SUNDRY NOTICES AND REPORTS ON WELLS
Do not use this form for proposals to drill or to re-enter an abandoned well. Use Form 3160-3 (APD) for such proposals.

8. Well Name and No.
Jicarilla 29-02-14 #32

PLUG AND ABANDONMENT PROCEDURE

CONDITIONS OF APPROVAL

Proposed P&A

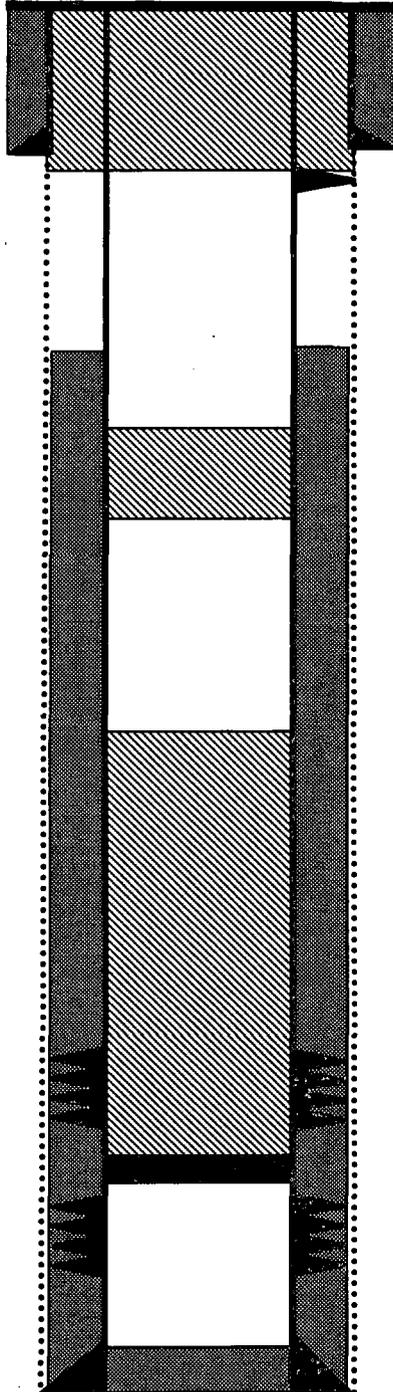
See COA
Plug #2: 1914' - 1814'
Class B cement, 17 sxs

1. Plugging operations authorized are subject to the attached "General Requirements for Permanent Abandonment of Wells on Federal and Indian Leases."
2. Farmington Office is to be notified at least 24 hours before the plugging operations commence (505) 564-7750.
3. The following modifications to your plugging program are to be made:
 - a) Set plug #2 from (1975-1875) ft. to cover the Nacimiento top
